# Reliability Analysis Update

Transmission Expansion Advisory Committee

May 11, 2021

# Changes to Existing Projects

# Dominion Transmission Zone: Baseline Possum Point 2<sup>nd</sup> 500-230 kV Tx

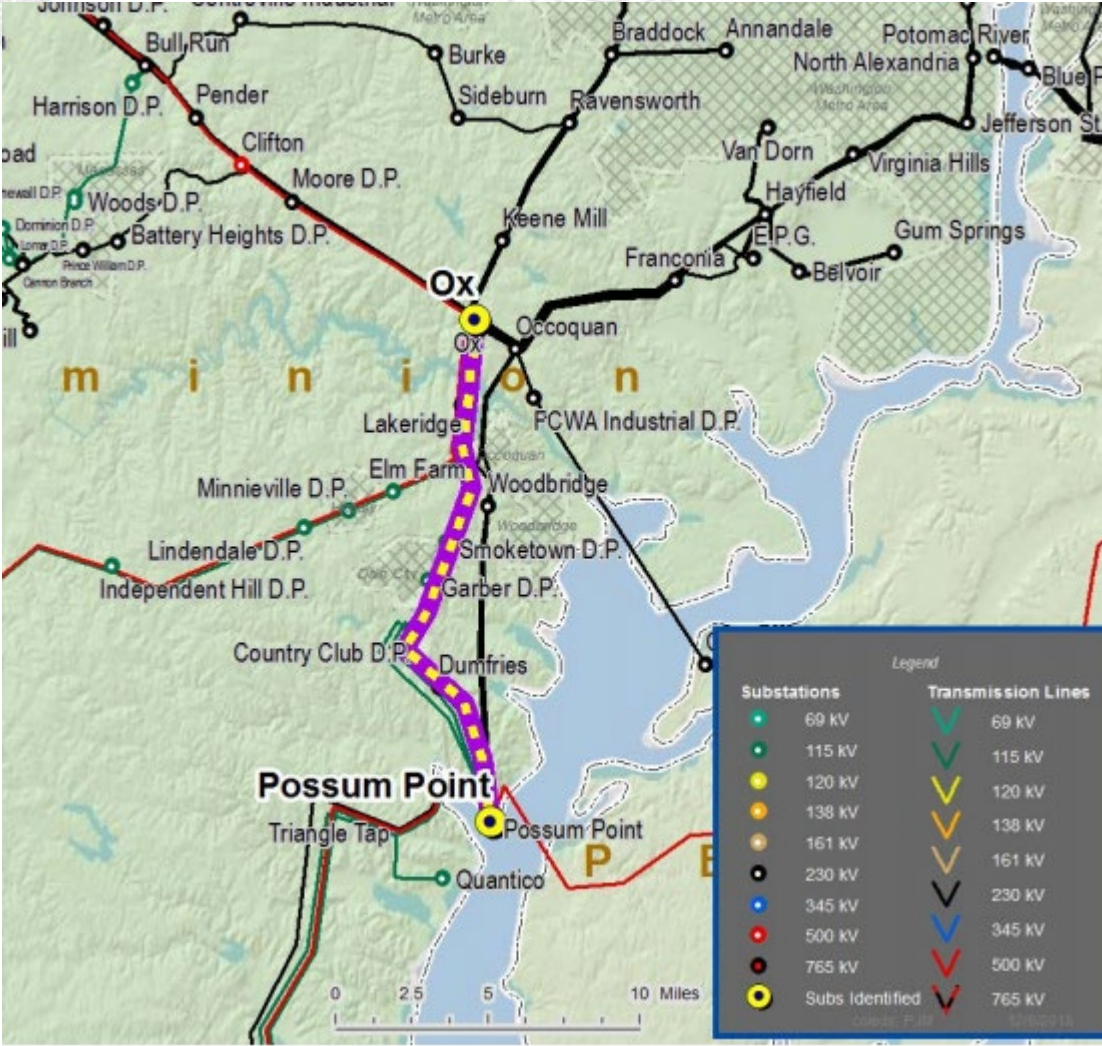
**Problem Statement:** Based on recent generation retirements (Possum Point Units #3 & #4) and the PJM 2018 Load Forecast updates indicates that for a NERC Category P1 – single contingency that Possum Point 500/230 kV Tx #1 overloads for a loss of the Possum Point – Ox 500 kV Line #571 under Dominion’s critical stress case criteria.

**Updated criteria evaluation:** Updated Summer 2023 & 2025 RTEP Models indicated deficiencies are no longer present. There were significant reductions in flows on the 500 kV System not only on the Dominion System but also the PEPCO Burches Tie Line for the 2024 and 2025 RTEP Models based on many factors. No single factor can be identified.

**Recommended Solution:** Cancel the Project.

# Dominion Transmission Zone: Baseline Possum Point 230kV Breaker Replacements

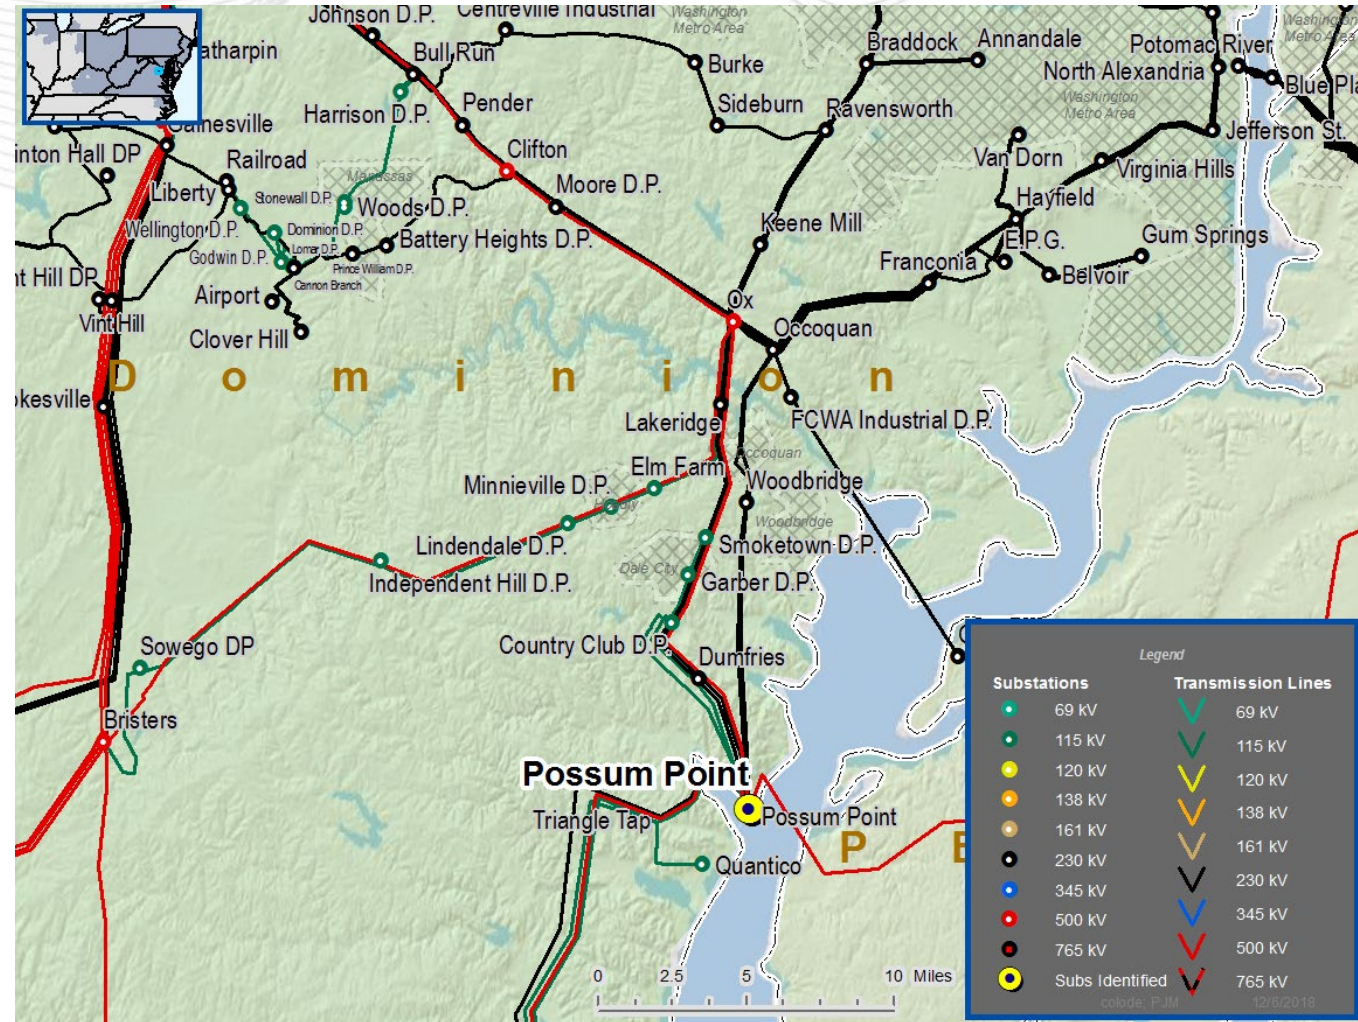
Nineteen (19) Possum Point 230kV breakers are over duty:

**Solution Cancellation Driver:** Possum Point 5 Retirement

**Recommended Solution Cancellation:**

**b2443.7:** Replace the nineteen (19) Possum Point 230kV breakers with 80kA breakers: H892, H8T2078, H992, H9T237, 23792, G6BTGT, GT92, 202292, 252T2022, 21592, G5T215, 25292, G492, G592, G6A92, G6B92, G4T2001, 200192, 207892
